**Re: FortisBC Inc. Certificate of Public Convenience and Necessity Application for the
Grand Forks Terminal Station Reliability Project ~ Project No. 1598987**

**COMMERCIAL ENERGY CONSUMERS ASSOCIATION
OF BRITISH COLUMBIA**

INFORMATION REQUEST NO. 1

**FortisBC Inc. Certificate of Public Convenience and Necessity Application for the Grand
Forks Terminal Station Reliability Project
Project No. 1598987**

Figure 6 – Risk of Failure Compared to a Transmission Utility

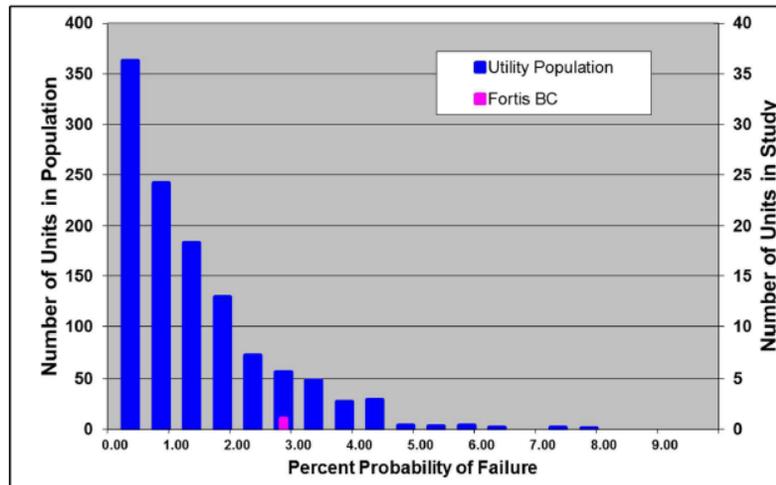
10.1 Please confirm that the 2.6 percent probability of failure identified in the chart is FBC's Risk of Failure for this individual unit, and not for FBC's units as whole.

10.2 If confirmed, please provide an estimate of the average probability of failure for these units for all of FBC, if possible.

- 10.3 Please provide FBC's assessment of how much the risk of failure will increase 'with each passing year'.
- 10.4 Does FBC have pre-established criterion for itself regarding the risk of failure for transformers such as this? Please explain and provide the criterion if applicable.
